**Town of Surfside  
PLANNING & ZONING BOARD  
AGENDA**

**January 28, 2021 – 6:00 p.m.**

**To:** Planning and Zoning Board  
**Thru:** Andrew Hyatt, Town Manager  
**From:** Walter Keller, PE, AICP., Town Consultant Planner  
Marlin Engineering, Inc.  
**CC:** Jason Greene, Assistant Town Manager  
Lillian Arango, Town Attorney  
**Date:** January 18, 2021  
**RE:** **924 88<sup>th</sup> Street – New Single-Family U/C 2<sup>nd</sup> Floor Modification**

**To:** Planning and Zoning Board  
**Thru:** Andrew Hyatt, Town Manager  
**From:** Walter Keller, PE, AICP., Town Consultant Planner  
Marlin Engineering, Inc.  
**CC:** Jason Greene, Assistant Town Manager  
Lillian Arango, Town Attorney  
**Date** January 18, 2021  
**RE:** 8835 Garland Avenue – Garage Conversion and Driveway/Hardscape Revisions

**SITE Plan**

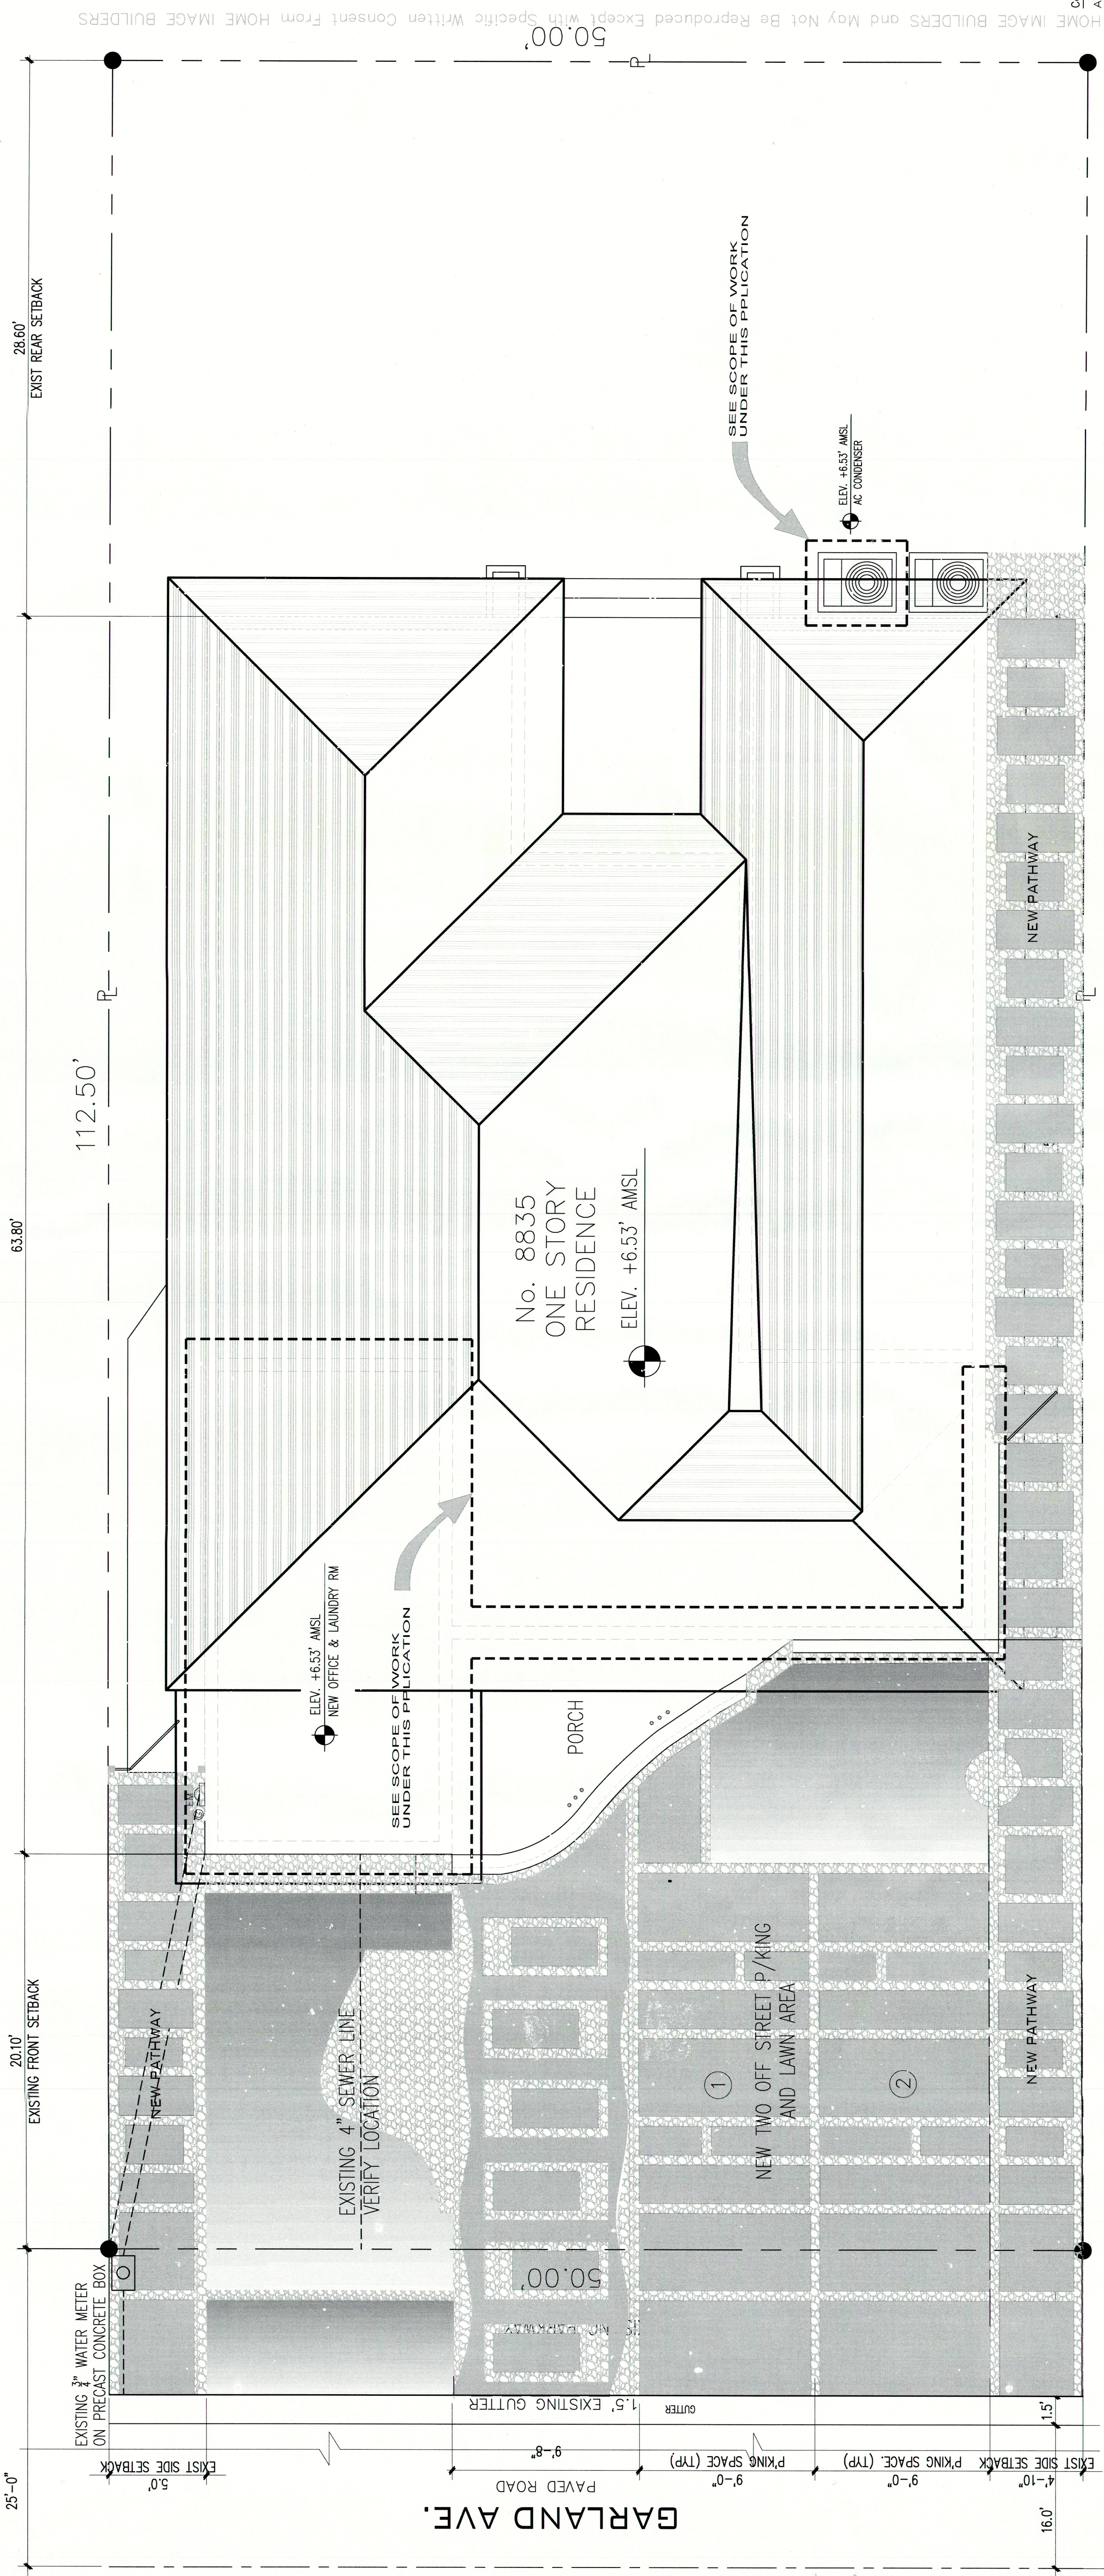
**Staff Recommendation:** The proposed garage conversion and front yard driveway hardscape modifications can be approved subject to the following conditions:

Provide 50% landscape area in the front yard with 20% of the landscape area Florida Friendly per the Code.

Remove concrete pads and stones from the public right of way except for access to the parking spaces.

Provide calculations and worksheets on the landscape area and locations of Florida Friendly species.
